Consolidated Comments for 01.161 and 03.1172 - E/S Woodbine Ave

APPLICATION FOR ZONING BY-LAW AMENDMENT AND SUBDIVISION

Location: E/S Woodbine Avenue, Keswick

Re: Request for Comments – 1st Submission - Zoning By-law Amendment 03.1169 & Draft Plan of Subdivision 01.161
York Region File Nos.: SUBP.22.G.0025 & ZBA.22.G.0085
23049 Warden Avenue
Part Lot 3, Concession 4
(1376389 Ontario Ltd)
Town of Georgina

DRAFT PLAN OF SUBDIVISION

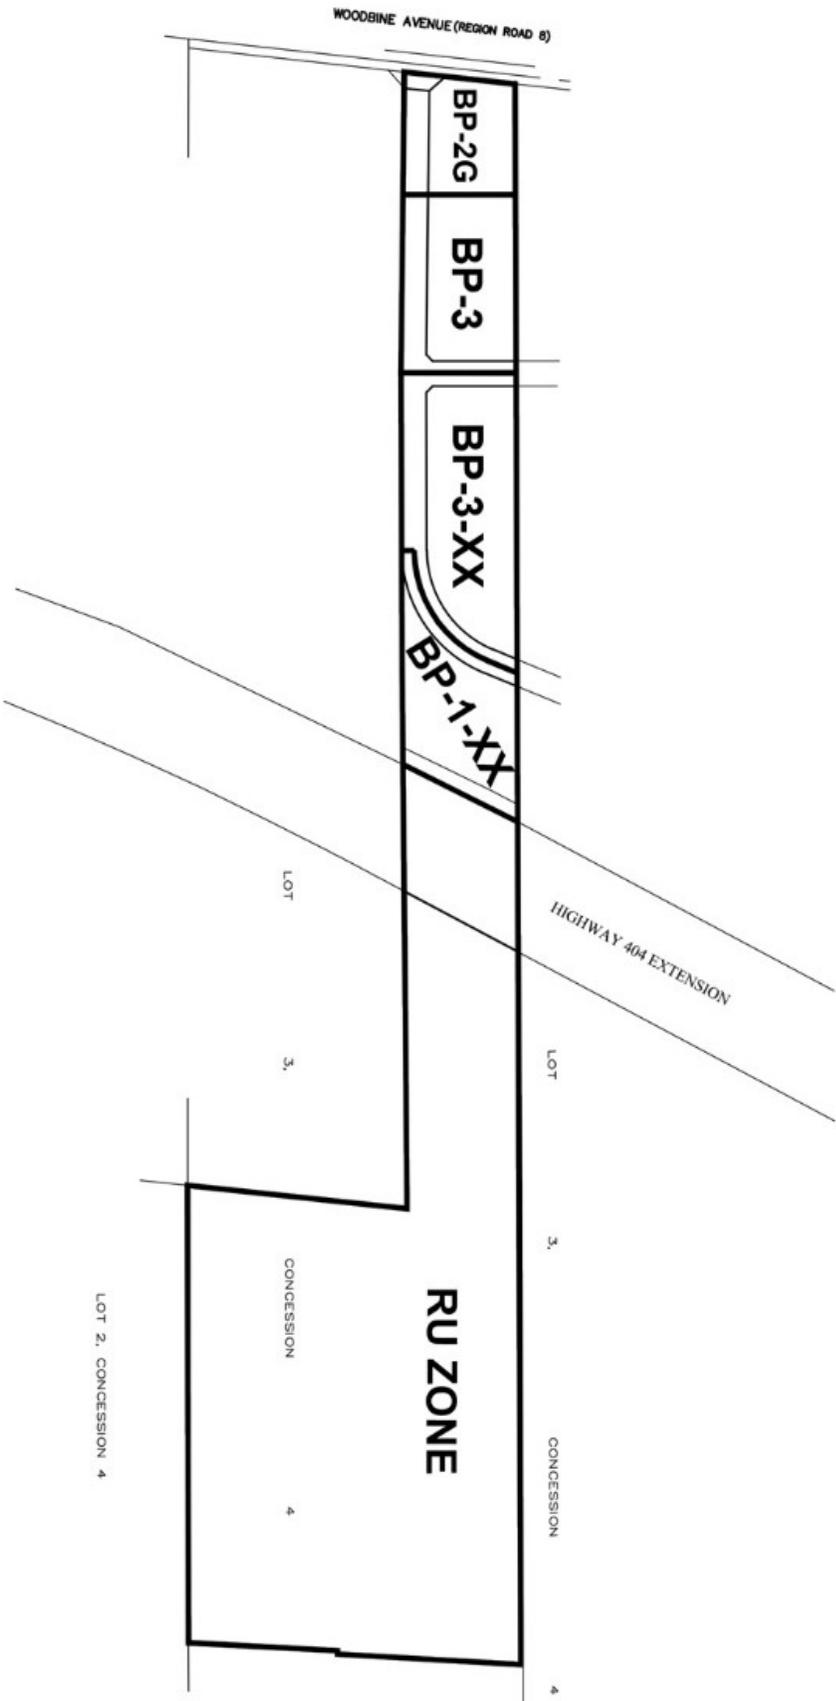
14. Street "B" in the Draft Plan of Subdivision should have a ROW of 26 m, this is going to be a major road in the Keswick Business Park running north to south. This road will also be the main connection to the future Glenwoods Ave, which Glenwoods Ave will be an interchange with Highway 404.

15. For Street "A" we require the ROW to be 26m up to Street "B" from the Woodbine intersection. This road will intersect with Woodbine and act as a major road in the south half of the business park. At the intersection Street A is expected to have two lanes, a right/thru lane and a left turning lane. The left turning lane length detail will only be determined at the time of detailed design and therefore we would require the 26m ROW from the Woodbine intersection to Street "B".

It appears from review of the Draft Plan of Subdivision, Blocks 4, 5, and 6 may locate within the regulatory floodplain. As it is understood that Block 4 is intended to be developed within the initial phase, and would include the proposed Truck Transport Depot, it should be demonstrated that no development or site alteration will occur within the regulatory floodplain. This is currently unclear, and in future circulations the extent of the regulatory floodplain should be illustrated on site plan drawings.

10. Clarify potential future uses for Block 6; and How will Block 6 (Other Lands owned by Applicant) be accessed in the future when Highway 404 Extension (e.g. Block 5) is developed?

11. Traffic access to Block 5 (Future Highway 404 Extension) and Block 6 (Other Lands owned by Applicant) will not be permitted via Woodbine Avenue.
12. Transportation Mobility Plan studies will be required to be submitted in the future for Blocks 1, 2 and 6, as part of future development applications, when development for the lands move forward.

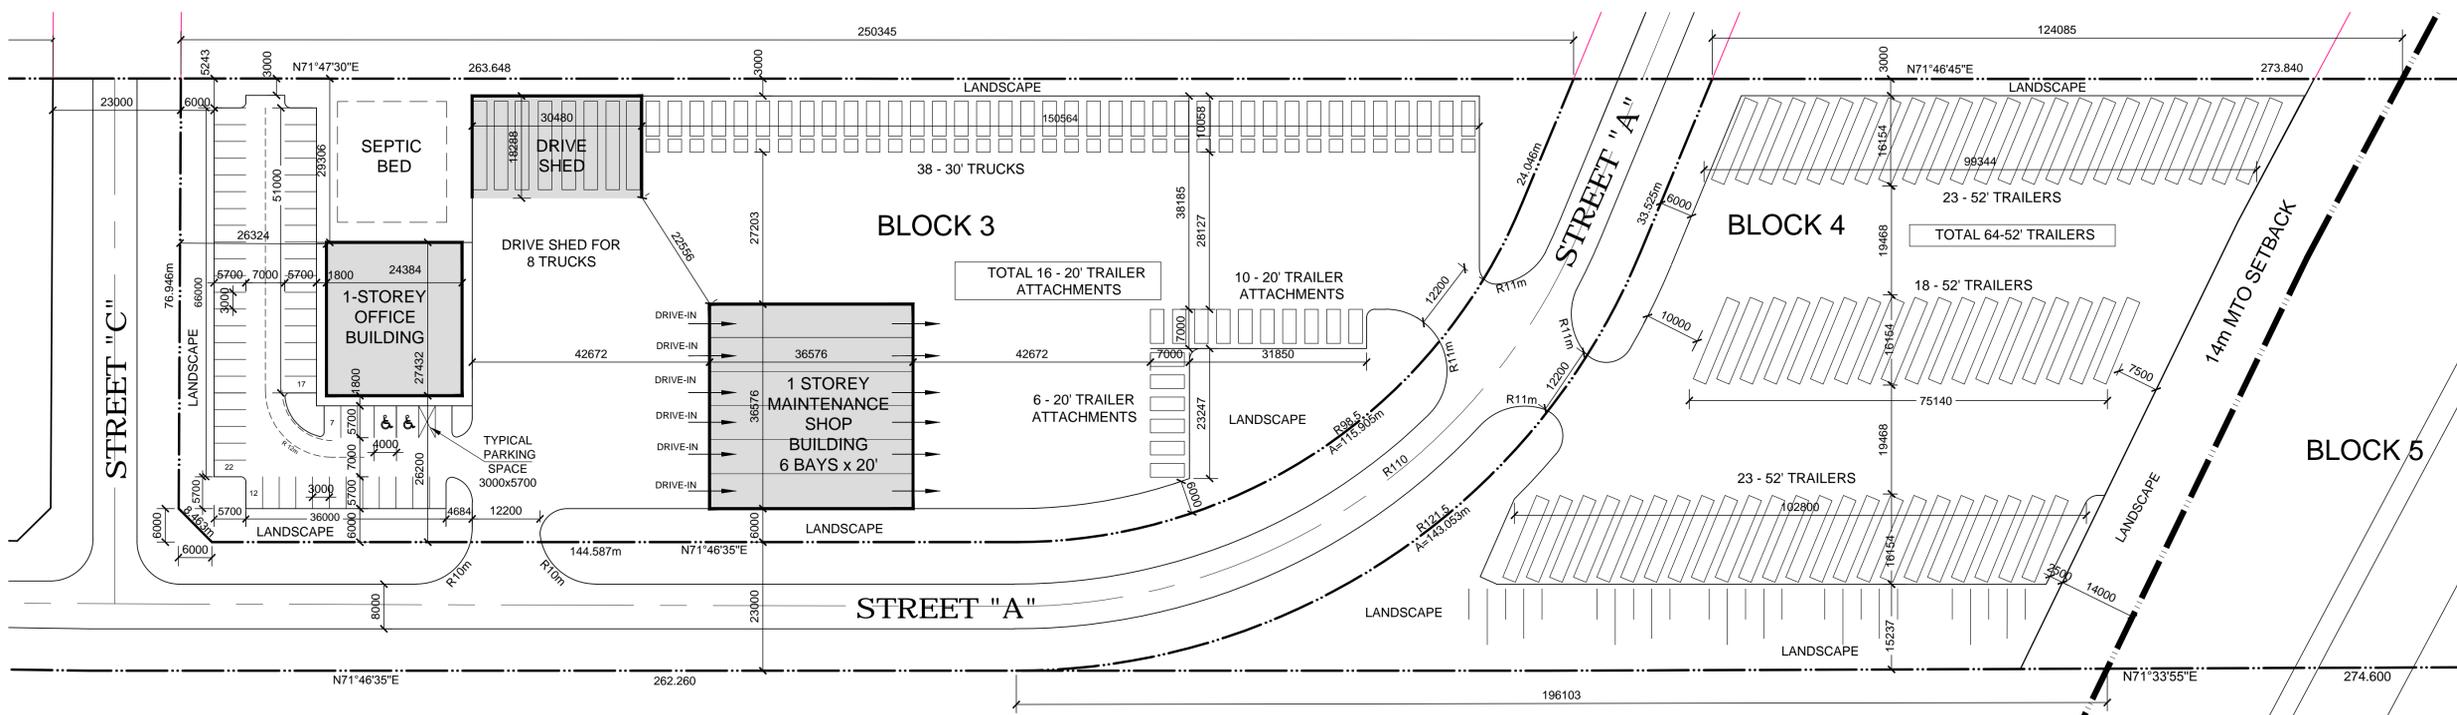
28. Location of 2nd septic tank to service the Maintenance Shop building is not shown.

25. Revise the trip generation to include to Drive Shed space or provide additional justification to the inclusion/exclusion of the Drive Shed shown on the concept plan in the calculation of site trips.
